September 13, 2013

ADDENDUM NO. 1
ELECTRICAL DISTRIBUTION SYSTEM UPGRADE
ON THE EDWARDSVILLE CAMPUS OF
SOUTHERN ILLINOIS UNIVERSITY EDWARDSVILLE
KNOWN AS "QUOTATION NO. 8929"

TITLE: DETAIL #1 - 4-CELL DUCTBANK	DRAWN BY: RJD	ATTACHMENT E0.1 (1)
PROJECT: SIUE ELECTRICAL DISTRIBUTION UPGRADE	CHECKED BY: RJD	
PROJECT No: 611-21E	DATE: 09/12/13

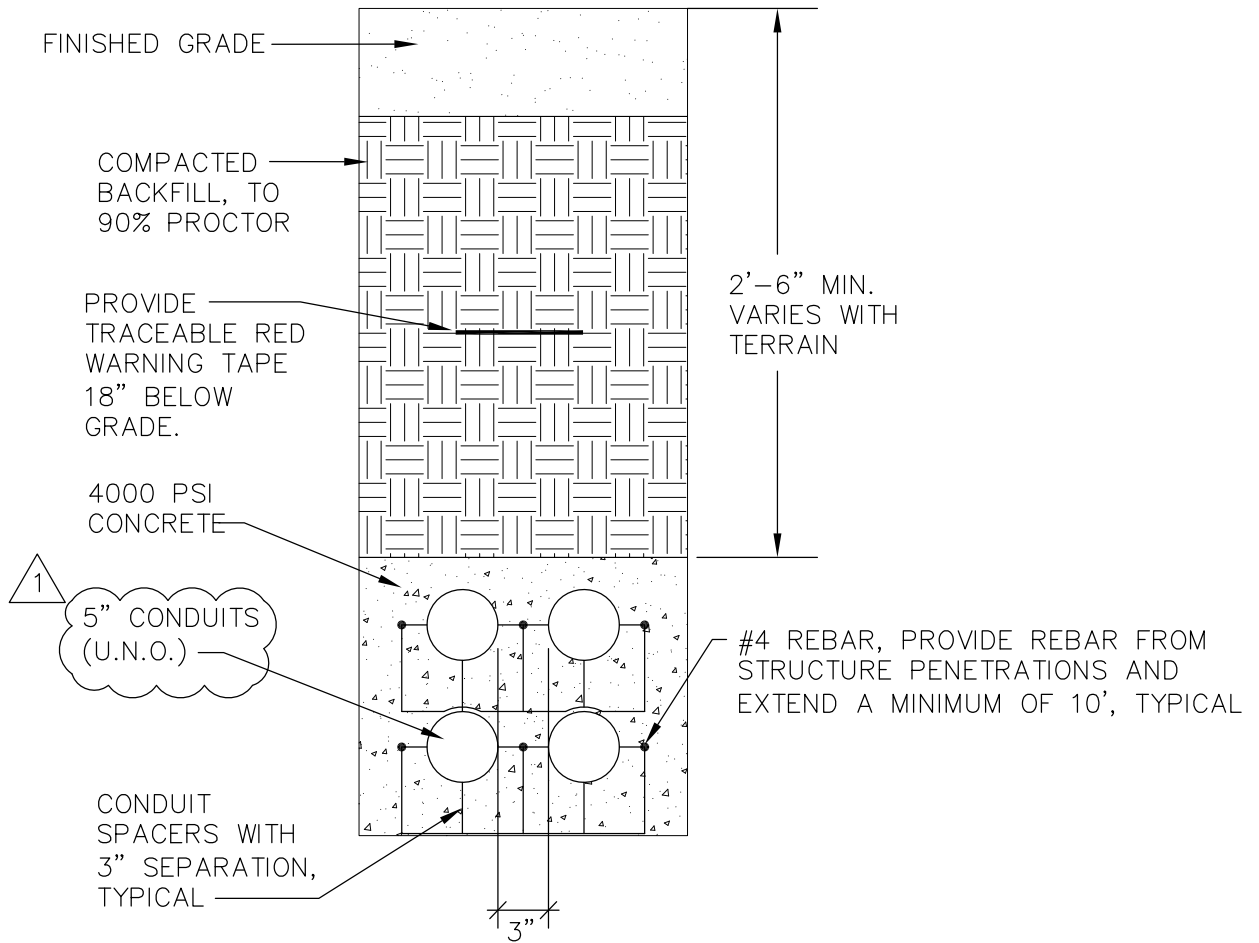
1. Sheet E0.1 ELECTRICAL DETAILS
 - a. **REVISE** detail #1, see attached sketch E0.1(1).
 - b. **REVISE** detail #1, see attached sketch E0.1(2).
 - c. **REVISE** detail #1, see attached sketch E0.1(3).

ATTACHMENT
E0.1(3)

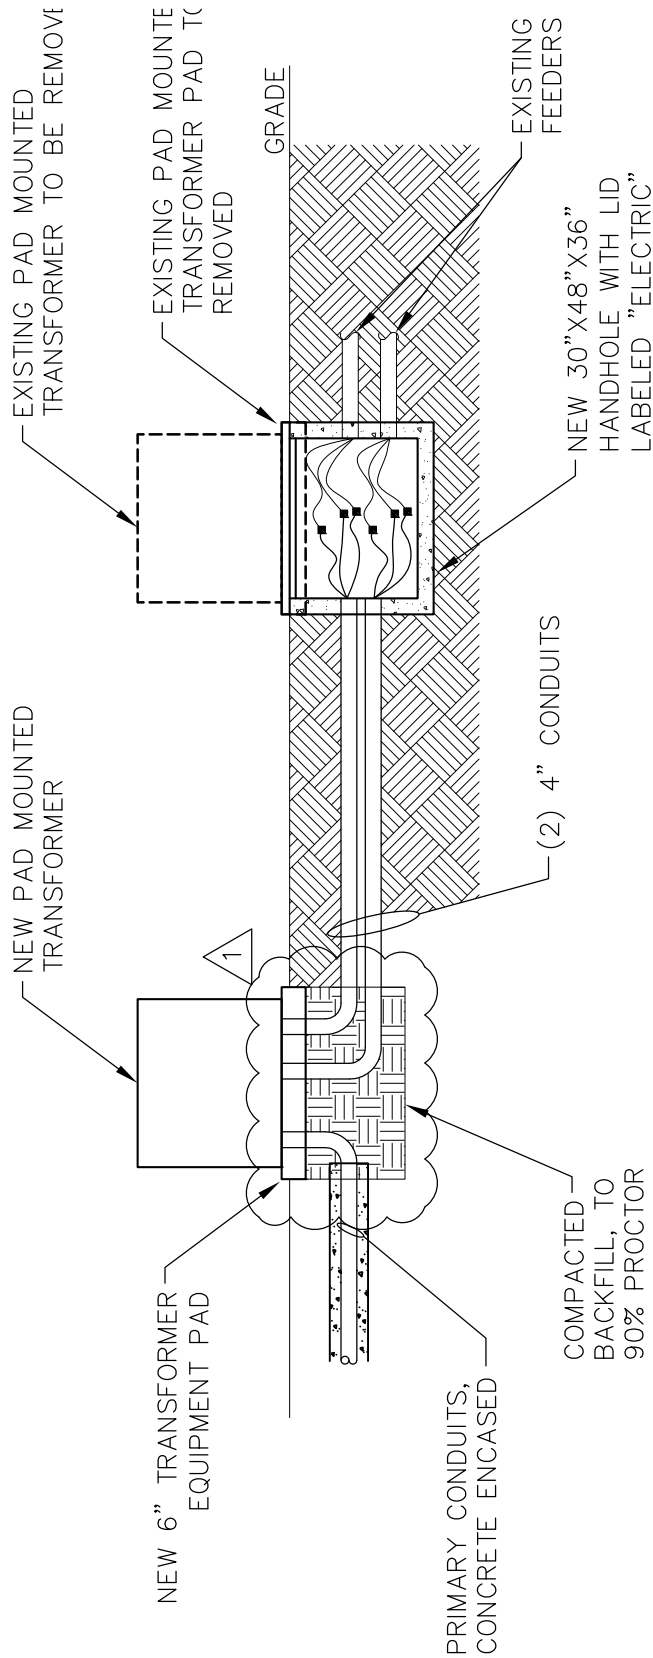
- d. **REVISE** detail #1, see attached sketches E0.1(4) and E0.1(5).
2. Sheet E1.4 ENLARGED ELECTRICAL SITE PLAN
 - a. **ADD** outline of laydown and project trailer location, see attached sketch E1.4(1).

TITLE: ENLARGED ELECTRICAL SITE PLAN	DRAWN BY: RJD	ATTACHMENT E1.4 (1)
PROJECT: SIUE ELECTRICAL DISTRIBUTION UPGRADE	CHECKED BY: RJD	
PROJECT No: 611-21E	DATE: 09/12/13

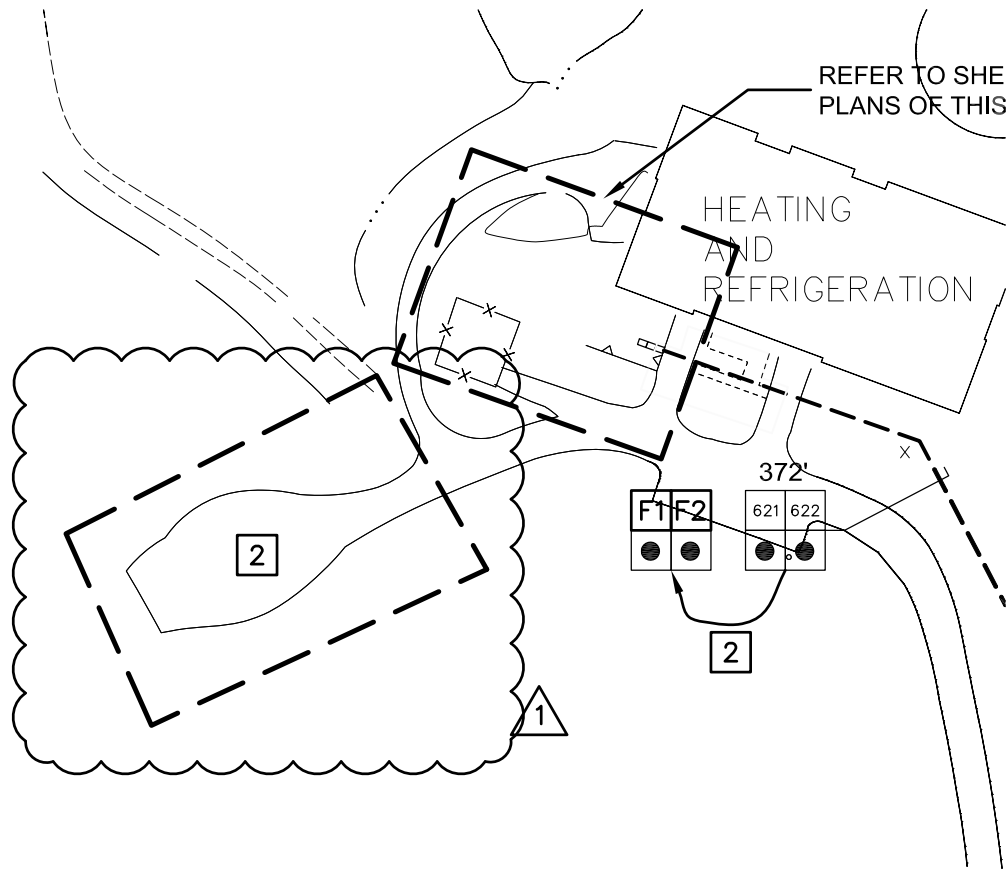
- Q15: Please provide the location of where the lay down and marshaling area is to be located.
A15: *The lay down area will be located near the H&R Plant.*

- b. **ADD** Keyed Note #11, see attached sketch E1.4(1).
3. Sheets E1.6-E1.11 GENERAL NOTES
 - a. **REVISE** General Note #1 to read; *"INDICATES NEW 15KV 133% INSULATED EPR COPPER CABLE TO BE PROVIDED WITHIN NEW DUCTBANK AS INDICATED. SEE THE ONE-LINE DIAGRAM ON SHEETS E3.1-E3.3 FOR ADDITIONAL INFORMATION. "A" INDICATES PHASE"*

A4: *The project trailers will be located near the H&R Plant.*

11 PROJECT TRAILERS, OFFICE TRAILER, AND LAY DOWN AREA SHALL BE LOCATED WITHIN THE OUTLINED AREA. NECESSARY POWER TO THE TRAILERS SHALL BE PROVIDED FROM THE H&R PLANT. THE POWER SHALL BE ROUTED OVERHEAD FROM THE TRAILER TO THE H&R PLANT AND SHALL BE ROUTED TO PREVENT INTERRUPTION TO THE UNIVERSITY. **1**

TITLE: ELECTRICAL ONE-LINE DIAGRAM – NEW	DRAWN BY: RJD	ATTACHMENT E3.1 (1)
PROJECT: SIUE ELECTRICAL DISTRIBUTION UPGRADE	CHECKED BY: RJD	
PROJECT No: 611-21E	DATE: 09/12/13

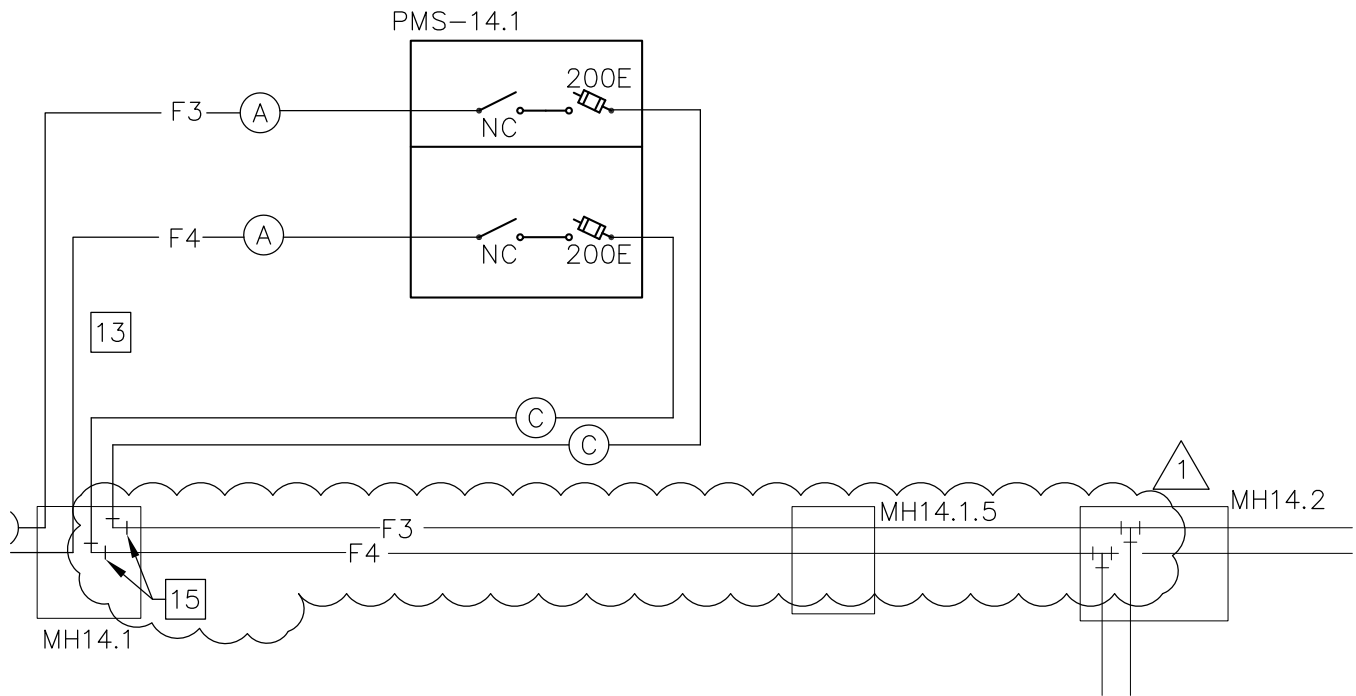
- Q14: Dwg. E3.1 near PMS-14.1 there is a keyed note 13 for Fault Indicators but no fault indicators quantity or designation is shown.
A14: *This keyed note was inadvertently located at this location and has been removed. Fault indicators are not required to be installed at this location.*

- a. **REVISE** the line type to cables from MH14.1 to MH14.15 to MH14.2 as existing to remain, see sketch E3.1(1).
 - b. **ADD** Keyed Note #15, see sketch E3.1(1).

15 PROVIDE (3) WALL MOUNTED 2 POINT JUNCTION POINTS MOUNTED WITHIN THE MANHOLE AND PROVIDE (3) DEAD BREAK SEPARABLE MODULAR CONNECTORS TO THE NEW 15KV EPR CABLES (3) DEAD BREAK SEPARABLE MODULAR CONNECTIONS TO THE EXISTING CABLES AND LAND THE CONNECTORS TO THE APPROPRIATE JUNCTION POINTS. SEE THE ENLARGED MANHOLE DETAIL FOR THE JUNCTION POINT MOUNTING LOCATIONS.
